Service Bulletin SB.JS-005

JS1 Tail valve V2 modification & inlet filter installation

Figure 1: a) Tail valve V2 with compression spring and without the filter; b) Tail valve V2 with the tension spring and filter

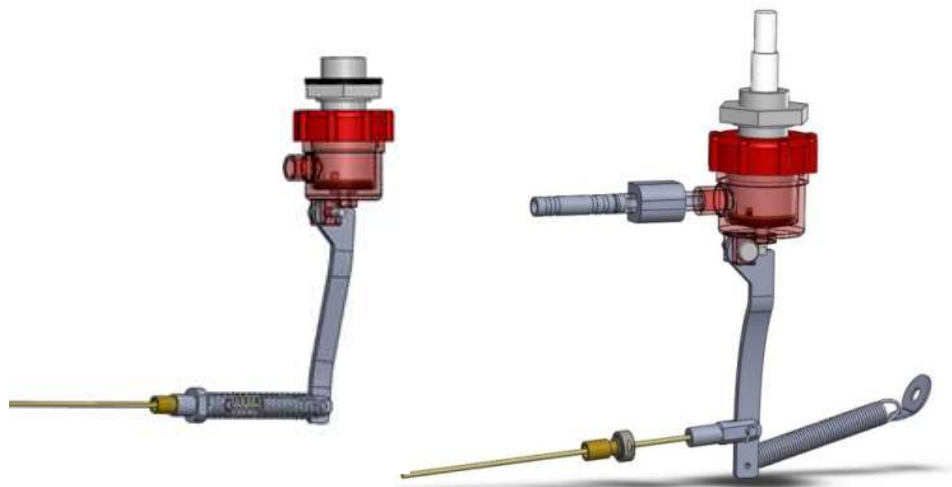
A filter (Fig 2, #11) has been added to the tail valve to prevent debris obstructing the valve plunger. The dump rate of the Tail valve V2 must be tested and if found less than 1 litre per minute, the tail valve must be modified accordingly:

1. The valve inlet must be modified to accommodate the installation of the filter and the internal diameter of the plunger increased. The filter must be cleaned if the dump rate is slower than specified.
2. The compression spring must be removed and replaced with a tension spring (Fig 2, #14) on the opposite side of the cable. The cable adjuster (Fig 2, #13) and clevis (Fig 2, #8) must be removed and replaced to accommodate the tension spring.

1. The procedure to remove and install the tail valve V2, with the following modifications incorporated:
 - a. Inlet filter installed to the valve inlet
 - b. Plunger modified to increase flow rate
 - c. Modified lever to accommodate the tension spring, modified clevis and cable adjuster.
2. The maintenance checks required to ensure correct operation.

Figure 2: tail valve V2 exploded view

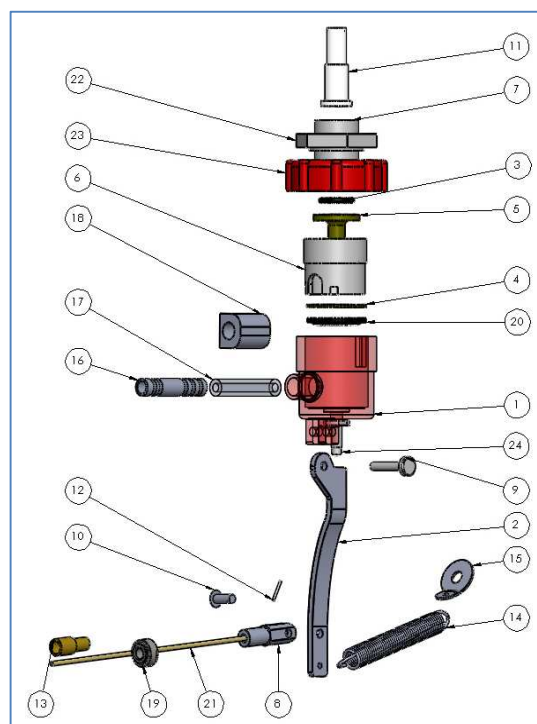
1. Remove the tail wheel and mud guard.
2. Undo lever by removing the hinge pin (See Fig 2, #9)
3. Remove the silicon tubing from valve body.
4. Undo the locking nut (See Fig 2, #22)
5. Remove tail valve by rotating the valve anti-clockwise.
6. Remove the valve inlet and replace with the valve inlet with the attached filter.
7. Reinstall the tail valve.
8. Tighten the locking nut by hand.
9. Attached the lever with the hinge pin.
10. Test the dump rate:
 - a. If found according to specifications, reinstall the tail wheel and mud guard.
 - b. If less than specifications the following procedure must commence:

Figure 5: Play specification between valve pin and lever,
lever and spring retainer, clevis and shear web.

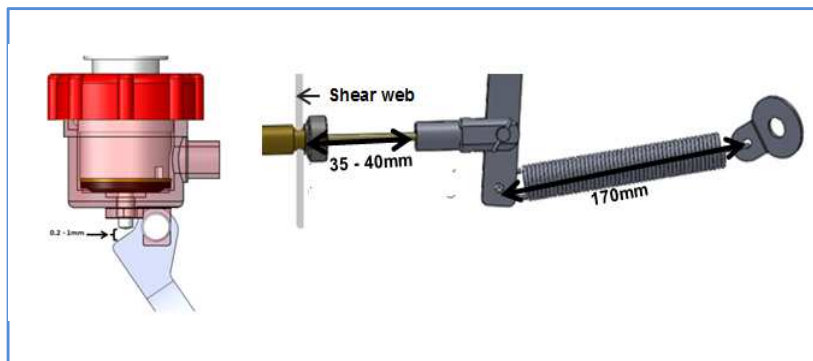
8. The arm (Fig 3, #4) may have to be fitted with an extra hole, as illustrated in fig 6. in order for the cable to fit. Removal and reinstallation as well as adjustment needs to commence as explained in the maintenance manual issue 2, par 6.6.4. Adjustment of the water ballast system.
9. Install the spring retaining washer (Fig2, #15) on the bottom rudder hinge bolt, at the rear end of the wheel box.
10. Install the lever to the valve body with the hinge pin (Fig2, #9)
11. Attached the cable to the clevis (Fig 3, #9) with the lever and clevis, (Assuring the valve is in the closed position) in the positions as illustrated in figure 6.
12. The tension of the cable can be adjusted with the clevis (Fig3, #9).
13. Install the mud guard and ensure there is no interference with the tail valve and actuators.
14. Install the tail wheel.
15. Test the dump rate and assure it is as specified.
